## PARTS & SERVICE NEWS

REF NO.	AA00169	
DATE	July 27, 2000

**SUBJECT:** MODIFICATION TO FACILITATE SQUARE FUEL TANK CLEANING

**PURPOSE:** To introduce modification procedures to facilitate cleaning drift from the square

Fig. 1 Section where mud and sand tend to accumulate

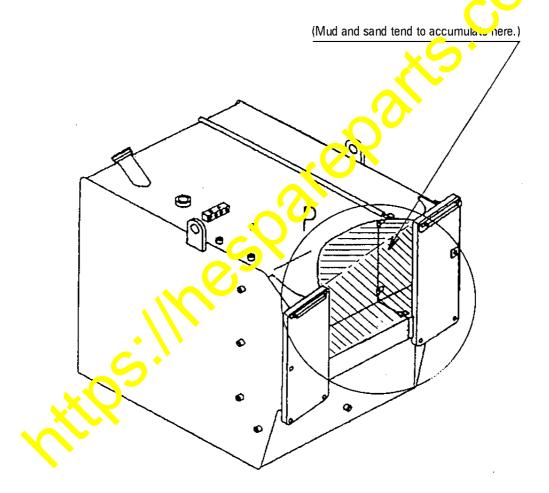
With the square fuel tank of the dump trucks of the model rames usted above, the space shaped like a pocket is formed at the section where the tank is mounted to the frame thus allowing accumulation of mud and sand, if this accumulates beyond the upper structe of the fuel tank, the dump truck when it is lowered may not be able to seat perfectly onto the guide.

- 3. Modification of the fuel tank (to supplement the mud and sand discharging holes) When it is not easy to remove mud and sand accumulating in the section "P" in Fig. 1 below, modify the fuel tank following the procedures outlined below.
  - (1) Open a \$\phi\$100 hole in each end plate at front and at rear of the tank, at the positions designated in the drawing. (At 1 place each on the front and rear end plates)
    Finish the bore surface of the opened hole to a smooth surface using a grinder. (Refer to Fig. 2.)
  - (2) Prepare pipes of the shape shown in Fig. 3. (2 units per vehicle)
  - (3) Open  $\phi$ 90 holes at the positions designated in the drawing in the channel plate (at 2 places each in upper and lower sections) and weld the prepared pipes. (Refer to Fig. 4.)

(Note) Urge your customers to remove mud and sand from the picket in the section "P" at the opportunities of periodical washing of the vehicle.
